MONTGOMERY COUNTY HISTORIC PRESERVATION COMMISSION
STAFF REPORT

Address:	15021 Dufief Mill Rd.	Meeting Date:	08/16/17
Resource:	Maple Spring Barns Master Plan Site	Report Date:	08/09/17
Applicant:	Jeff Fuller (agent for owner)	Public Notice:	08/02/17
Review:	HAWP	Tax Credit:	partial
Case Number:	02/02-17A	Staff:	Dan Bruechert
Proposal:	Barn conversion to pre-K – primary school, and other modifications

STAFF RECOMMENDATION

MAIN ENTRY DOORS

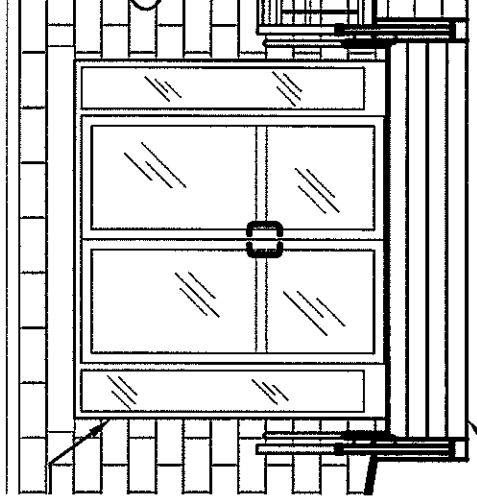
In order to use the ground floor as classroom space, the applicant is proposing to excavate the ground floor several inches. To best accommodate this change the applicant is proposing to lower the front entrance, stairs, and ramp accordingly. The current front entrance is a modern design with residential-style doors with sidelights accessed by a concrete block front porch and ADA compliant ramp. The new proposal will lower the entrance by approximately 8" (eight inches) and install a contemporary glass entrance. The lowered entrance requires a new stair and ramp. The new porch and single-run ADA ramp will be constructed out of pour-in-place

concrete and a metal railing. These materials are consistent with the existing ramp and are generally in keeping with the character of the building in its modified form. Additionally, the single-run ramp will have less visual impact on the building than the existing double-run ramp and Staff supports this change.

Roof coating product - Color as shown

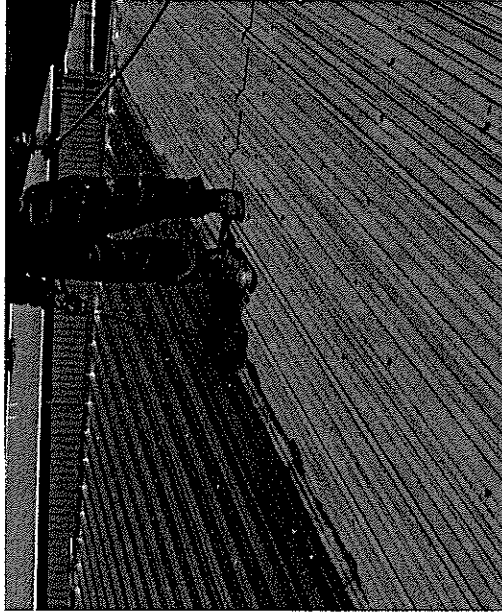
The applicant is also proposing to coat the historic metal roof using Alumanation 301. The coating is an asphalt based coating, containing 15% metal that is sprayed directly onto the roof. The resulting finish is said to be highly reflective which is consistent with the current appearance of the historic barn. The applicant has provided technical specifications for HPC review with the application materials. Staff does not have any experience with this specific product, however, it appears that the coating is thin enough that the roof will still read as a 5-V metal roof after the product application. It does not appear that this treatment will potentially damage the historic fabric and complies with Standard 6 and should be approved.

FENCING DETAILS

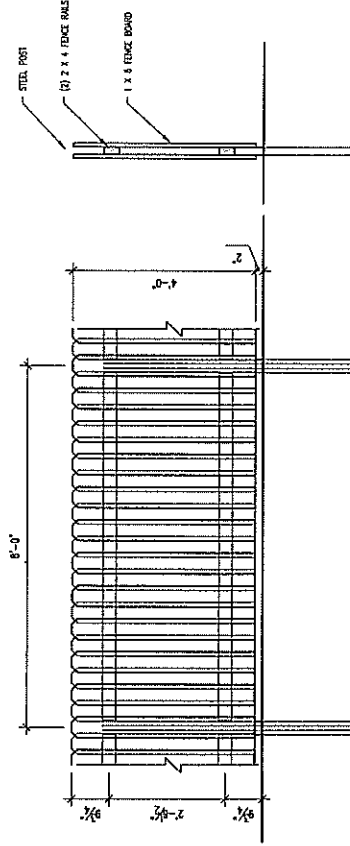
The southwestern portion of the site includes a paved area and a wooded section which drops off steeply to a stream. The applicant proposes to remove some of the paved area and install grass and to construct a 42" (forty-two inch) tall split rail fence with vinyl mesh. While the vinyl mesh is not generally an approved material when used in conjunction with a wood fence, because of the site's use a school, Staff recognizes the unique safety challenges and supports this fencing proposal.

Roof valley view from on roof

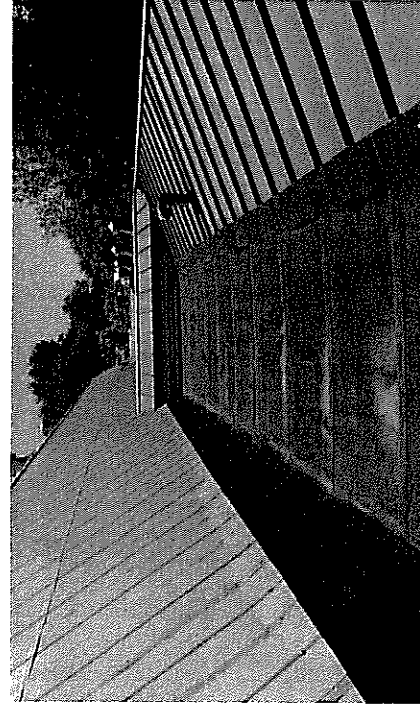
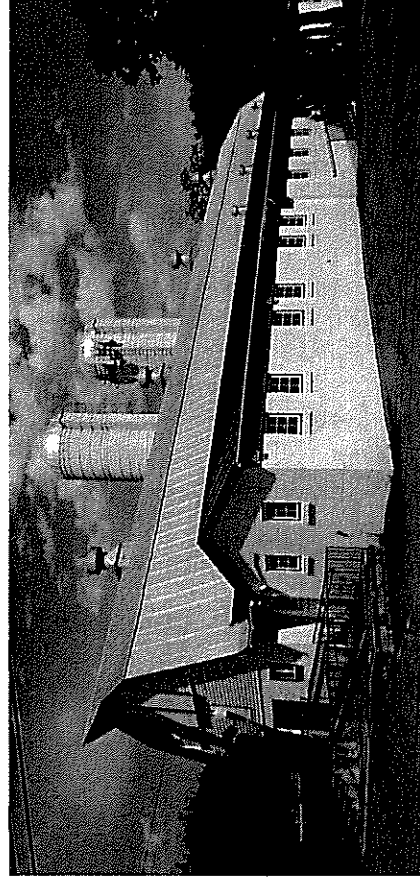
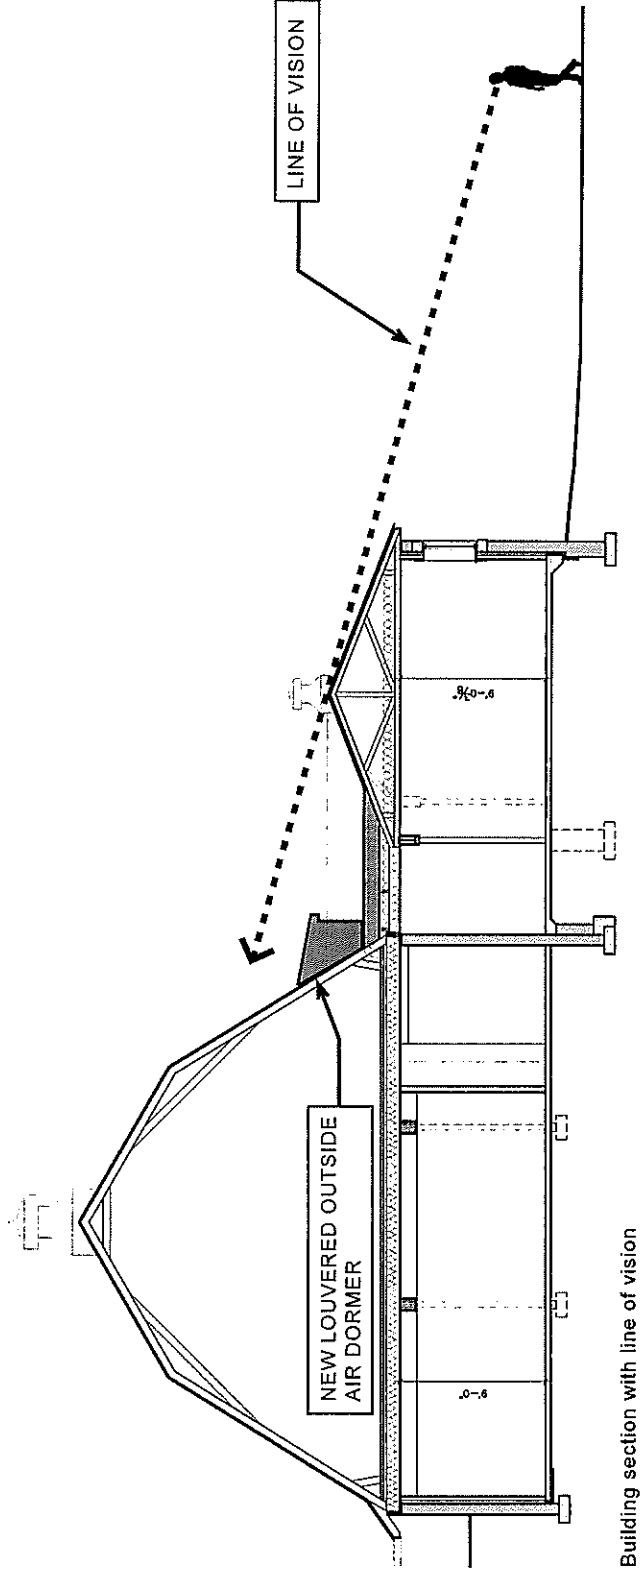
The proposed louvered penthouses will be installed on the roof valley between the roofs of the historic barn and the non-historic block addition. They will be minimally visible from the surrounding site as shown on the attached plans. This is a necessary mechanical system for the barn's continued use and will not detract from the historic character of the barn. The applicant did not provide exterior materials specifications and Staff recommends this element be approved with the condition that material specifications must be submitted and approved with final approval authority delegated to staff.

- Details for the louvered penthouse must be submitted with final authority for approval delegated to staff.
